2012 Geotechnical Annual Review, Minto Mine, YT

MINTO EXPLORATIONS LTD.

SRK Consulting (Canada) Inc.

November 2012

8 Mill Water Pond

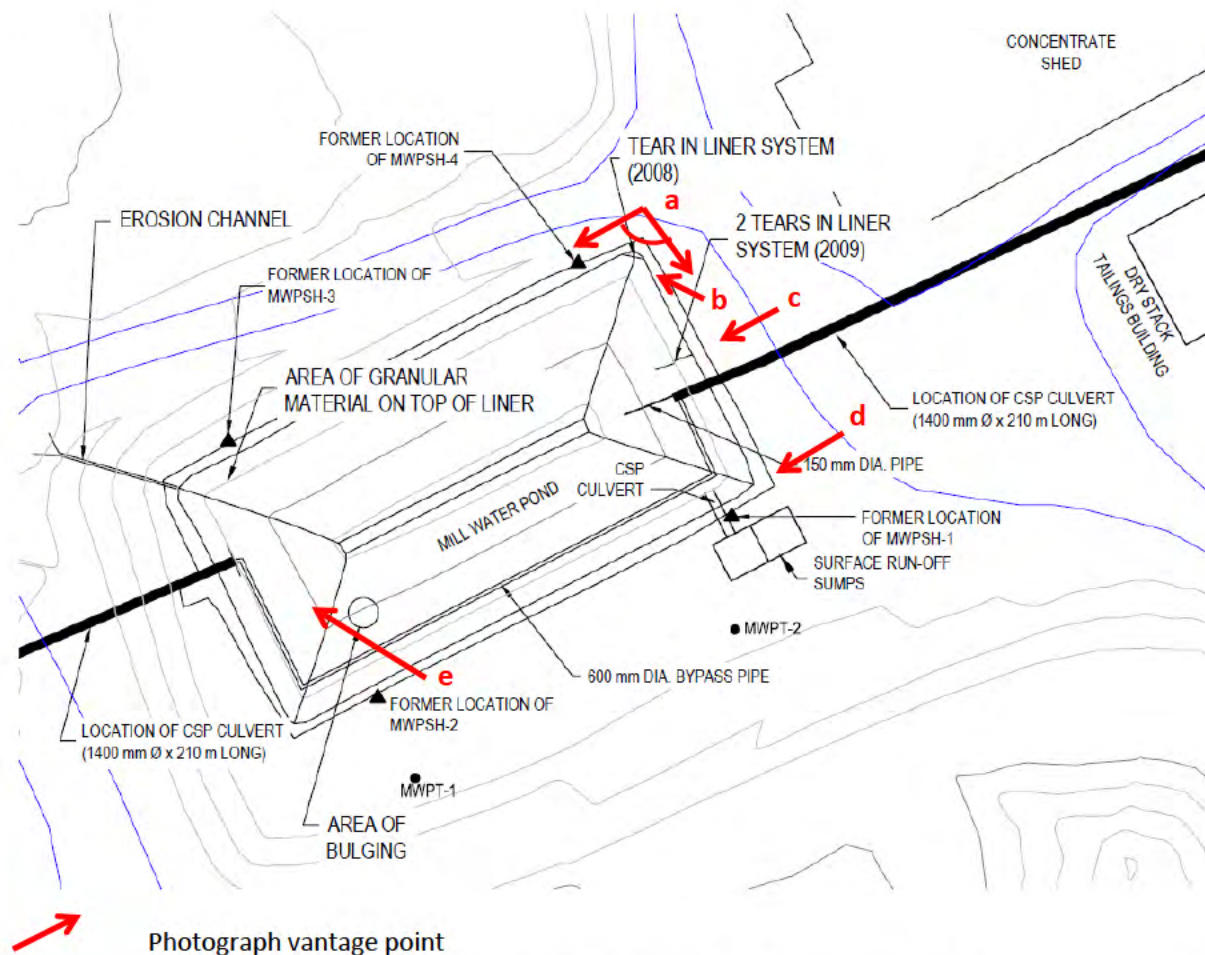
- a) Panoramic view of the mill pond. Tears in the liner system are the same as that reported in the previous inspection. No new tears or liner defects were observed.

- b) View of the tear in the liner at the north corner of the pond. The tear is approximately 1m in length and first noted in the 2008 inspection.
- c) Two tears in the liner midway along the northeast edge of the pond. These tears were first observed in the 2009 inspection. The largest tear is approximately 1.5m in length and is parallel to the slope. The smaller tear is approximately 0.5m in length and is orientated across the slope. A void is present beneath the slope that in previous EBA inspections has been noted to be increasing in size due to water penetration from surface.

- d) View of the south east side of the pond and by-pass pipe.
 - The bypass pipe and metal clamps are resting on pieces of plywood, while the 2011 review notes that they were resting directly on the liner. Placement on plywood is an improvement, but particular attention should be made at each support for liner damage in future inspections.

- The 2011 observation of a “minor bulge under the liner system in the vicinity of the southwest corner” was not observed during this visit. The liner in the area did not appear to be stressed or contain defects.

8 Mill Water Pond

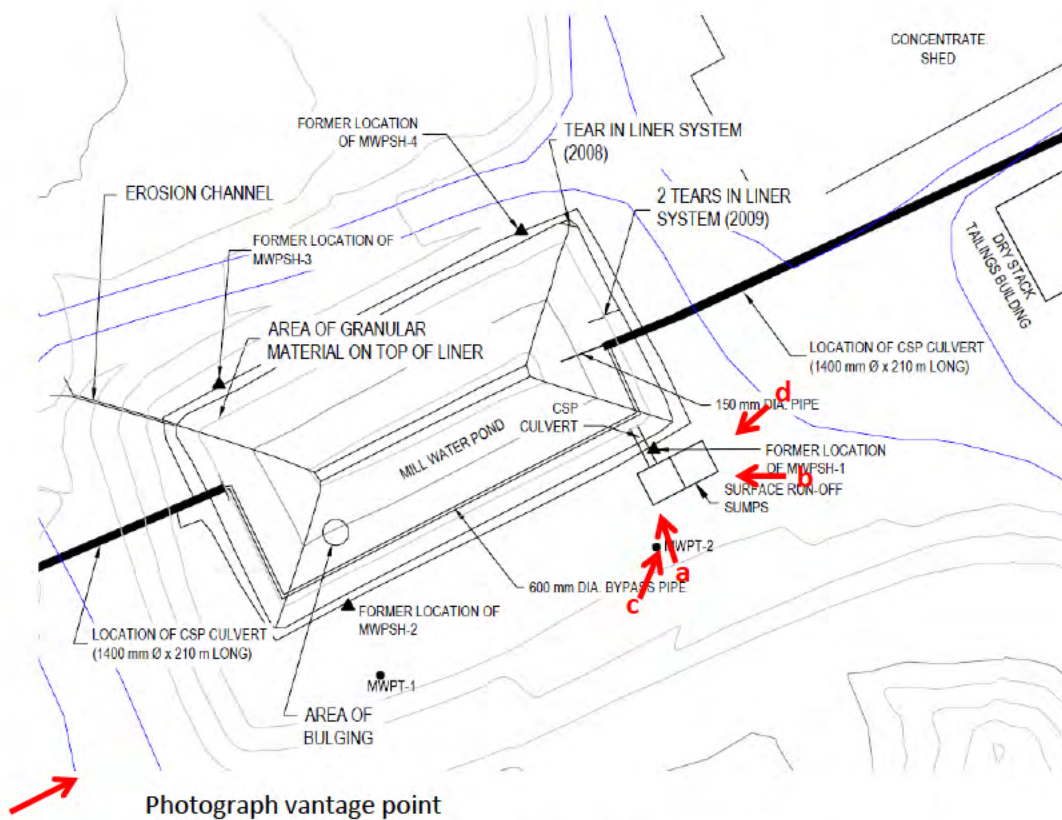
- Photos show the condition of the surface runoff ponds south east of the mill water pond.
- There are significant sediments in both ponds, each culvert, and outside the ponds to the east. It is recommended that each pond/culvert be cleaned.

- The liner tears should be patched the next time a liner crew is onsite. For the liner tear noted in Photo (c), Figure 14, sand should be placed to fill the void beneath the tear.
- The liner condition beneath the bypass pipe supports should continue to be monitored.
- The sediments accumulated in the surface runoff ponds and culverts should be cleaned out.

9 Fuel Containment Facility

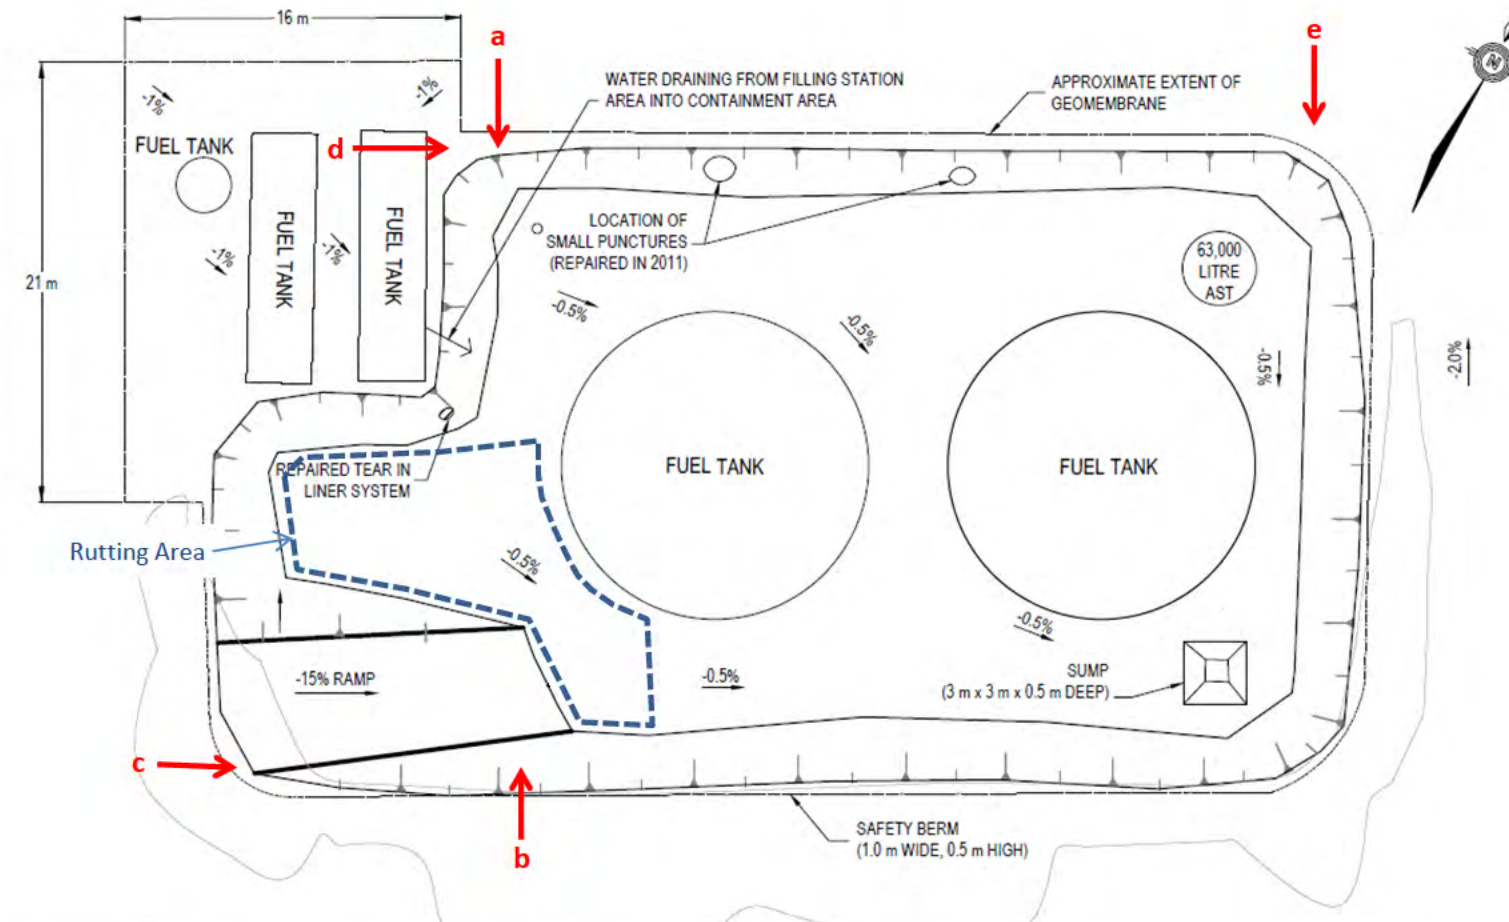
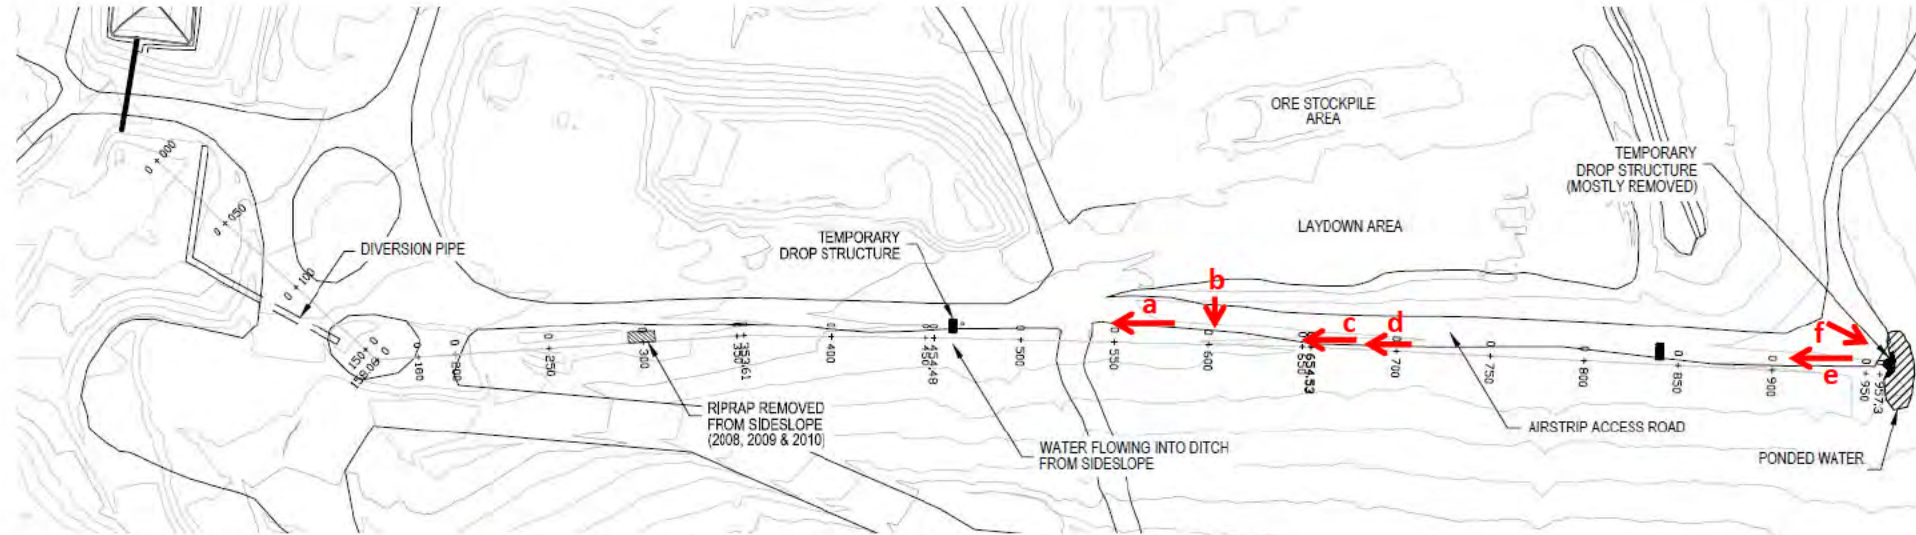
- Photos (a) to (e) show the condition of the liner on each side of the facility.
- Conditions of the facility appear to be the same as reported in the 2011 review.
- No tears or defects in the liner were observed.
- Ponded water is present throughout the facility.
- No ponded water was observed at the filling station area northwest of the containment area. The area appears to drain into containment area as per design.
- Ruts are present at the base of the ramp and at the western portion of the facility as seen in Photo (b). It is unclear if the ruts are new or the same as in the 2011 inspection.

- No actions required.
- As noted in the previous EBA inspections, the bedding layer over the geomembrane was not meant for heavy equipment. Vehicle access should be limited to the occasional visit with low ground pressure equipment.

11 Water Storage Pond Dam

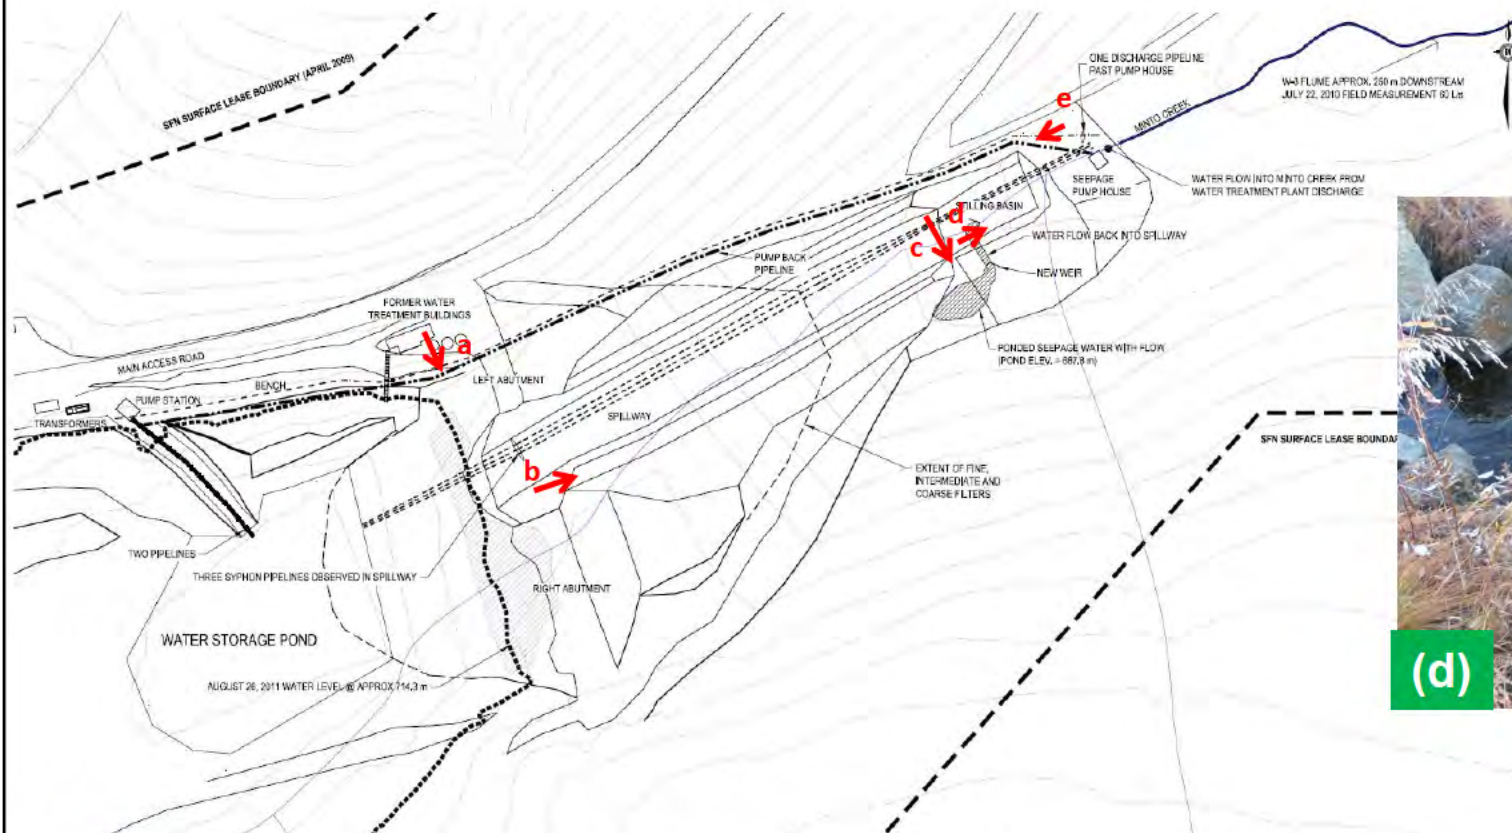
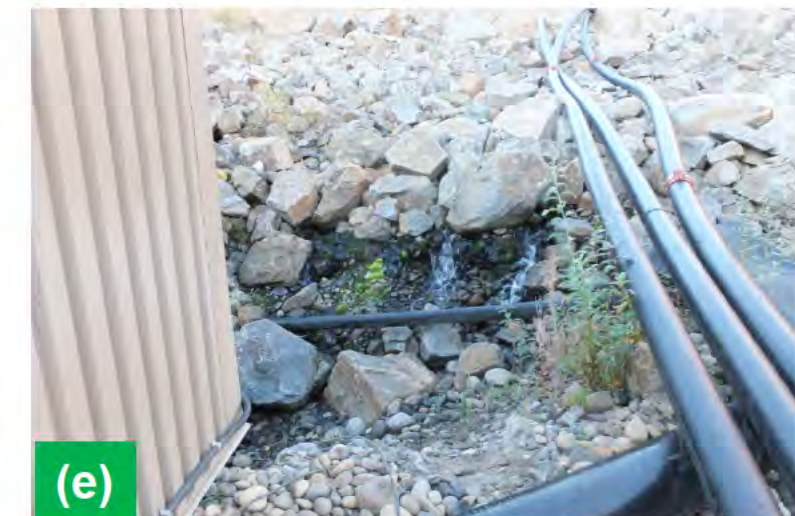
- Conditions of the dam appear to be unchanged since the 2011 Physical Observation Report issued by EBA on Oct. 5, 2011.
 - The WSP water level was estimated to be approximately the same as during the 2011 (714.3 m) estimated based on photographs provided in the 2011 report.

- The crest, upstream slope and abutments shows no signs of instability (settlement, bulging, slumping).
 - During the 2011 inspection, a minor erosion channel was noted in the general fill in the water treatment building pads. The erosional channel could not be found during the 2012 inspection.

- View of the downstream slope and spillway.
 - Three 200 mm diameter siphon pipelines are present in the spillway that run from the water storage pond to the seepage pump house.

12 Big Creek Bridge

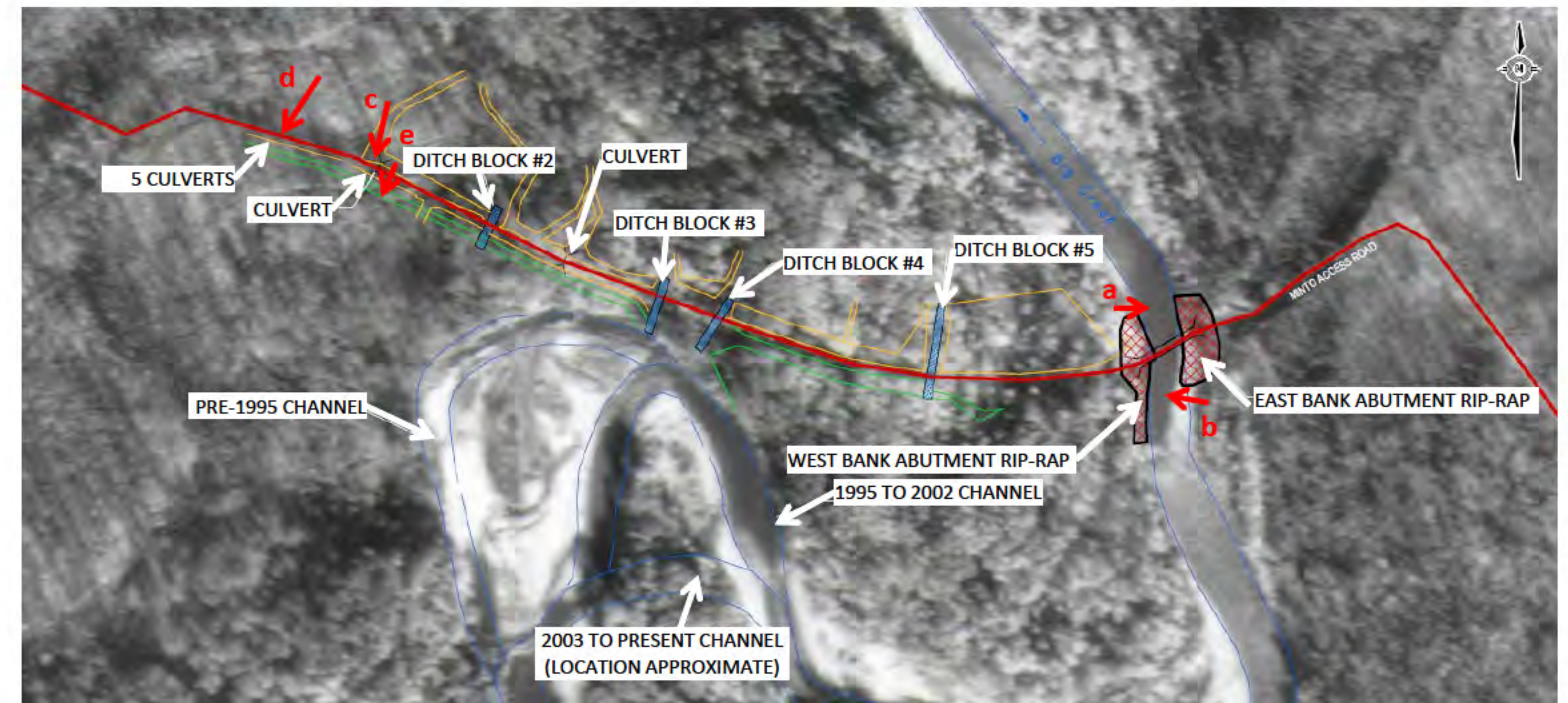
- Photos (a) and (b) show east and west abutments, respectively. The bridge abutments and road approaches are in good condition, no signs of instability were observed.

- Photo (d) shows 5 culverts, each with a diameter of 1.1 m, are located further west in the approximate location shown on the plan. The culverts are not noted in the 2011 inspection and likely installed within the past year. The culverts are in satisfactory condition. The middle culvert has been slightly damaged (dented) by a large rock.

- Continue regular annual monitoring of sediment accumulation in the culverts, and clean out if sediments continue to accumulate.
